MIL-T-81624(AS)
Amendment - 1
30 December 1969

MILITARY SPECIFICATION

TELEVISION DISPLAY REQUIREMENTS FOR THE WEAPON SYSTEM FOR GUIDED WEAPON MARK 1 ALL MODS (WALLEYE) AND GUIDED WEAPON, PRACTICE MK 4 MOD 0/1

This amendment forms a part of Military Specification MIL-T-81624 dated 18 March 1969 and has been approved by the Naval Air Systems Command, Department of the Navy.

FIGURE 1. COMPOSITE VIDEO PARAMETERS

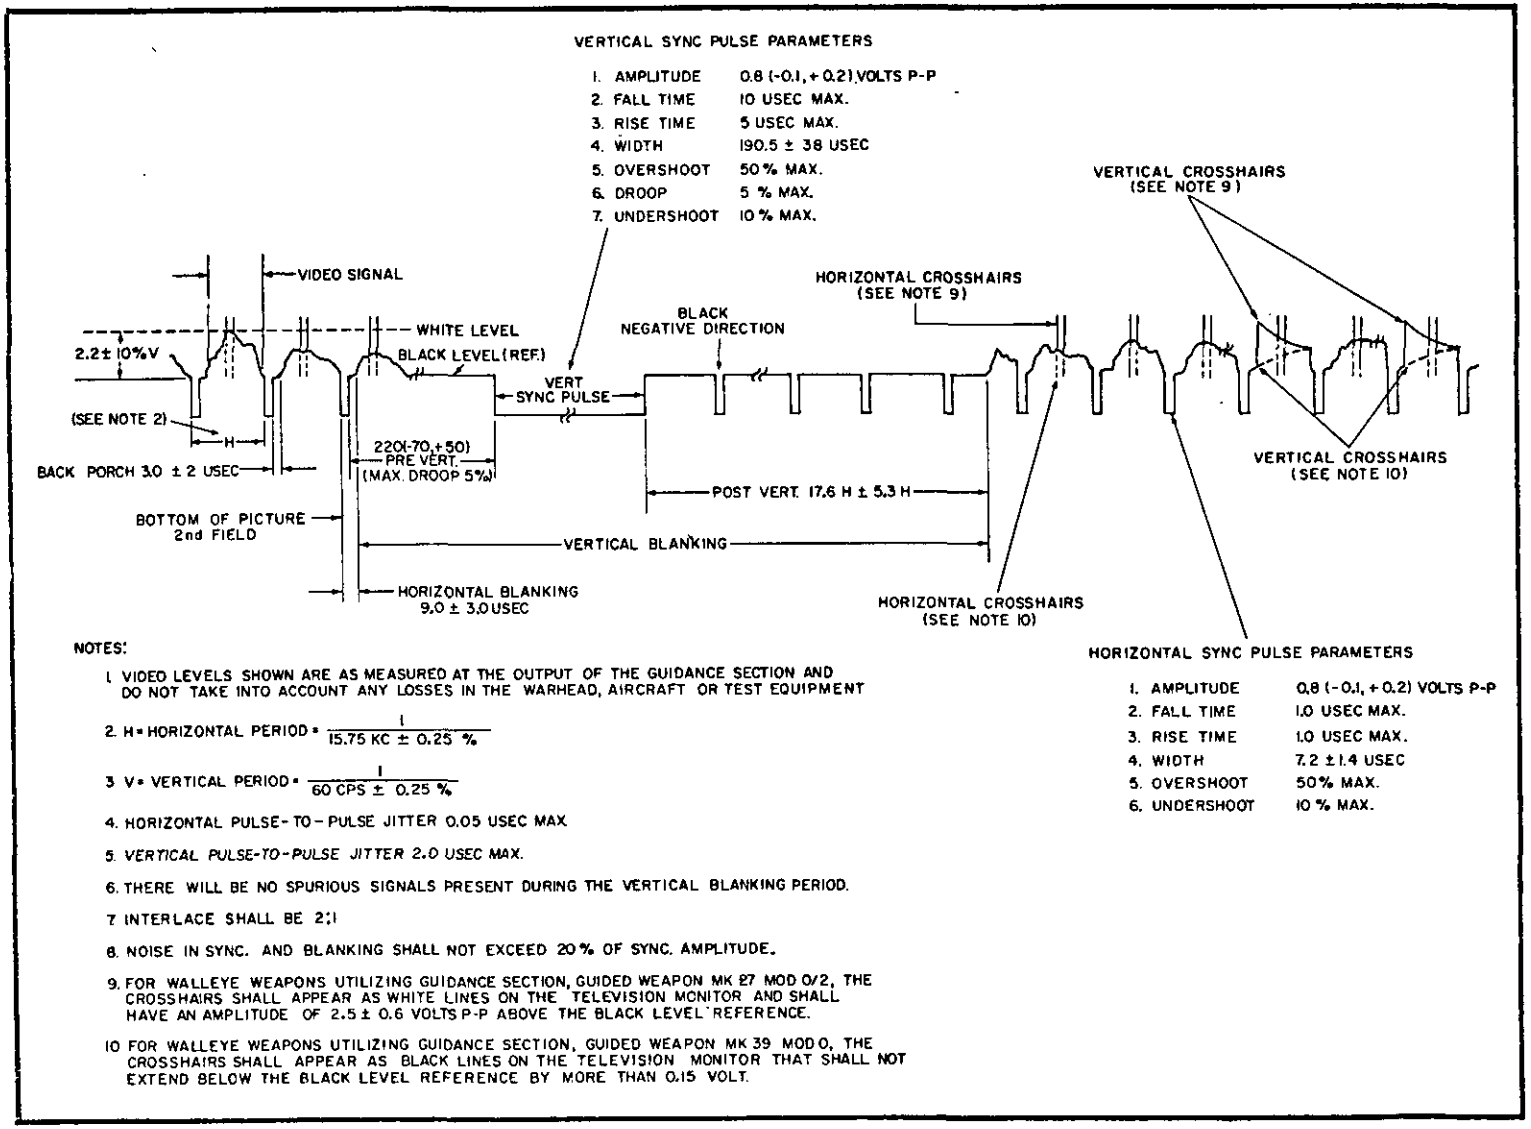
Page 8, Figure 1: Delete and substitute the new Figure 1 of this amendment.
